<b>Docket Number:</b>	15-AFC-01
<b>Project Title:</b>	Puente Power Project
<b>TN #:</b>	220217
<b>Document Title:</b>	Supplemental Testimony of Dr. H. Andrew Gray
<b>Description:</b>	Intervenors' Sierra Club Los Padres Chapter, Environmental Coalition of Ventura County and Environmental Defense Center Supplemental Testimony of Dr. H. Andrew Gray
<b>Filer:</b>	Alexa Zimbalist
<b>Organization:</b>	Sierra Club
<b>Submitter Role:</b>	Intervenor
<b>Submission Date:</b>	7/14/2017 4:32:46 PM
<b>Docketed Date:</b>	7/14/2017

**Supplemental Testimony of Dr. H. Andrew Gray**

**Supplemental Testimony of Dr. H. Andrew Gray**

**Figure 1. Average plume vertical velocity (m/s) vs. height (ft) for LM6000 (1 Stack)**

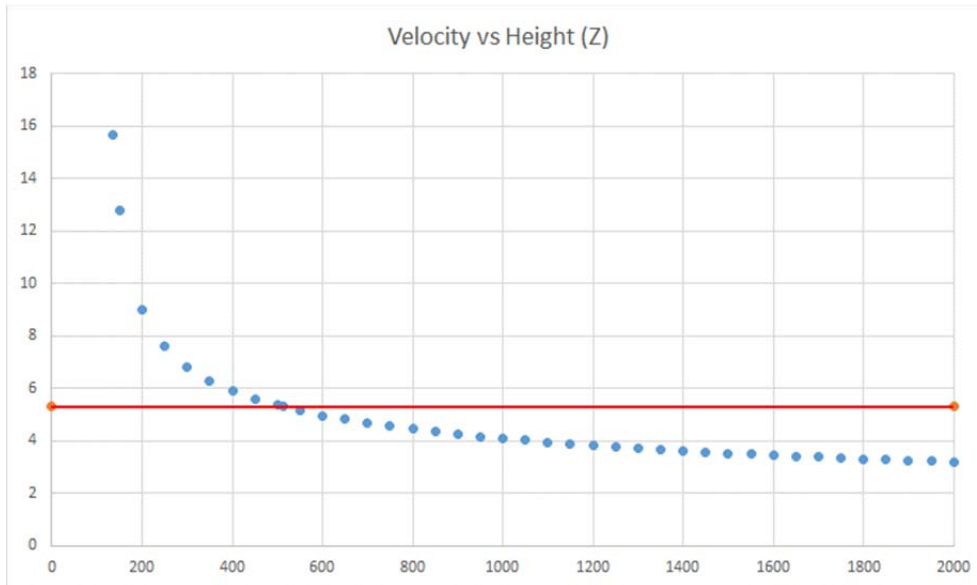
To answer this question, I first replicated the CEC Supplemental Testimony’s calculations of critical height for each of the alternative facility designs. I set up a spreadsheet to reproduce CECs velocity calculations using the Spillane Approach for the single stack GE7HA CTG and the single stack LM6000 CTG Alternative.<sup>14</sup> I was able to identically re-create their tabulated results for the GE7HA (1 Stack) and the LM6000 (1 Stack), as shown in CEC’s Tables 4 and 5.<sup>15</sup> CEC’s Table 5 indicates that the average plume velocity for the LM6000 using the Spillane Approach would be 5.36 m/s at 500 ft and 4.97 m/s at a height of 600 ht. Using the Spillane model, I determined that the critical height (at which the vertical velocity equals 5.3 m/s) would be reached at a height of 512 ft.

Figure 1, below, shows the plume average vertical velocity versus height for the LM6000 CTG (1 Stack) Alternative using the Spillane Approach (these results match the results shown in CEC’s Table 5). A red line has been placed on Figure 1 at the threshold velocity of 5.3 m/s. The calculations also show that the vertical velocity is computed to be 2.32 m/s at a height of 5000 m, 1.48 at 10,000 m height, 1.46 m/s at 20,000 m, and 1.07 m/s even as high as 50,000 m (with a very wide estimated plume diameter of 5 km). The “unfettered” plume rise that is featured in the Spillane model does not appear to accurately represent the plume's vertical velocity at these very high altitudes.

**Figure 2. Average plume temperature (K) vs. height (ft) for LM6000 (1 Stack)**

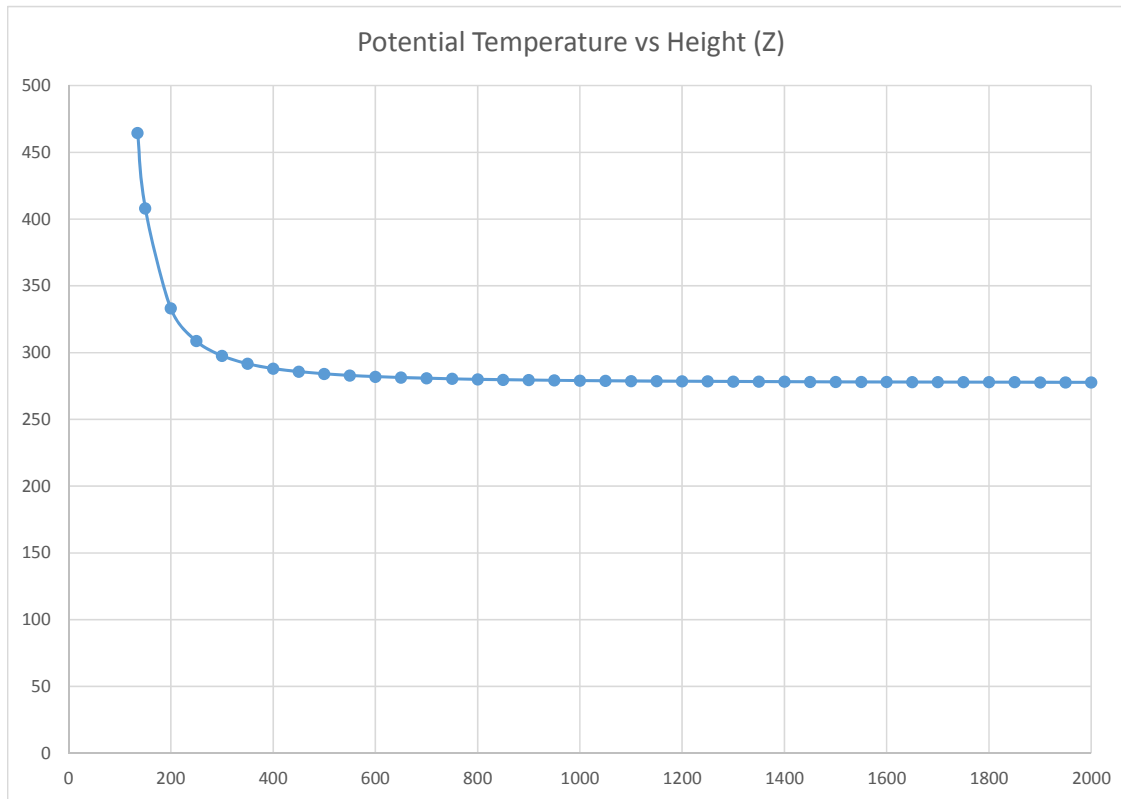
The average plume temperature can be computed at various heights using the Spillane methodology. Figure 2, below, shows the estimated average potential absolute temperature (K) versus height for the LM6000 CTG unit (1 Stack), using the Spillane Approach.

At the critical height (512 ft), the modeled diameter of the expanding plume using the Spillane Approach is estimated to be 41 m (135 ft) across, with a predicted average vertical velocity of 5.3 m/s. The average temperature of the expanding plume at that height is predicted by the Spillane model to be 283.8 K (51.2 F), just **6.5 K** degrees warmer than the ambient air (39.4 F). The buoyant force due to such a small temperature difference is extremely weak.

**Figure 4. Cross-section of Bivariate Normal Distribution “Fit” to Velocity Profile. The choice of  $\sigma$  affects the “shape” of the curve, resulting in different values of  $V_{\max}/V_{\text{avg}}$ .**

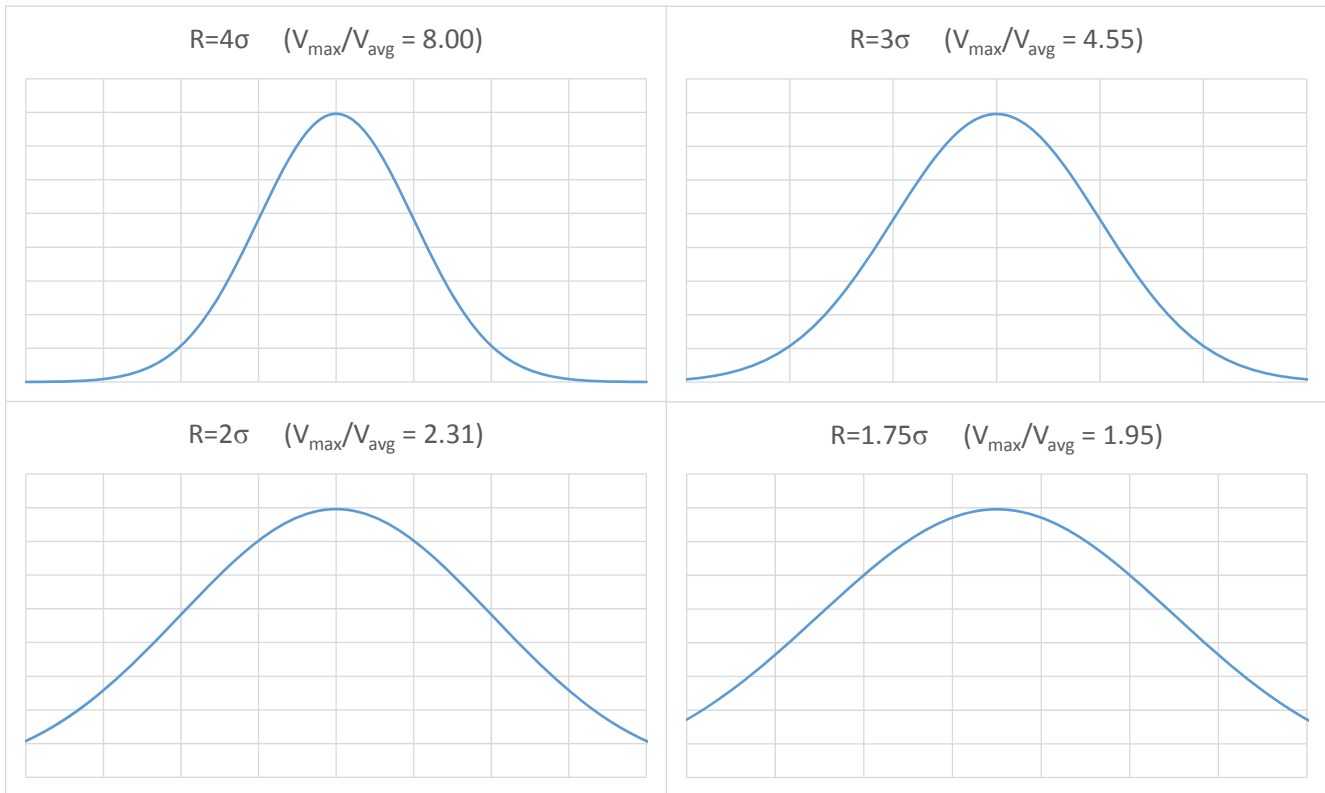
The problem with trying to “fit” the radial velocity profile to the bivariate normal distribution is further illustrated in Figure 4, which shows the vertical velocity profile across the width of the plume (from edge to edge), “fit” to the cross-section of the bivariate normal distribution. All four curves shown in Figure 4 have the same maximum velocity and each represent *a portion* of the bivariate normal distribution shown in Figure 3. Changing how much of the distribution is allowed to fit between the plume edges (i.e., the choice of  $\sigma$ ) dramatically affects the peak to average ratio (as was also shown in Table 4).

To use the bivariate normal distribution to represent the velocity profile across the plume, one must select the lateral extent, or width, of the normal distribution to include between the center point and the "edge" of the plume, where the velocity is zero. Figure 4 (and Table 4) shows that, when using the normal distribution to represent the velocity profile, the velocity at the plume edge is NOT zero (even for  $R=4\sigma$ ). For example, for  $R=2\sigma$ , the velocity at the plume edge is shown to be  $0.135$  \* the maximum value. The choice of width is completely arbitrary -- Roisin justified setting  $R=2\sigma$  based on the (incorrect) assumption that  $2\sigma$  would capture 95 percent of the distribution. (For the 2-D bivariate version of the normal distribution, a  $2\sigma$  radius actually only captures 86.5% of the distribution.) However, that inaccuracy is not the issue! The problem is that one can choose ANY point as the width (for example,  $1.75\sigma$ ,  $2\sigma$ ,  $3\sigma$ , or  $4\sigma$  could all be considered to be reasonable choices) -- and one could always argue that including more of the distribution (or almost all of it), would produce a more accurate result -- but including more and more of the distribution actually forces the average value to go down *all the way* to zero! Yes, that is true: the average value of the *complete* normal distribution which extends from negative infinity to positive infinity is actually ZERO! -- which is an uncomfortable mathematical reality when you are trying to use that distribution to fit to actual physical data and are relating the average value to the peak value!
